Appl. No. 10/774,326
Amdt. Dated October 6, 2006
Reply to Office Action of July 12, 2006

Amendments to the Drawings:

The attached sheet of drawings includes changes to FIG. 2 to delete reference sign 6a, replacing the original FIG. 2 sheet.

FIG. 2

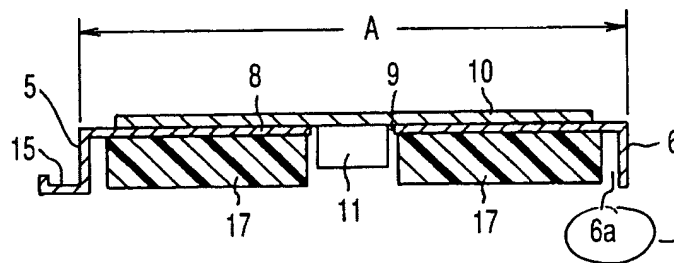
On page 2 of the Action, the drawings were objected to under 37 CFR 1.84(p)(5). In response, FIG. 2 has been amended to address the above objection. Reconsideration and withdrawal of the objection are respectfully requested.
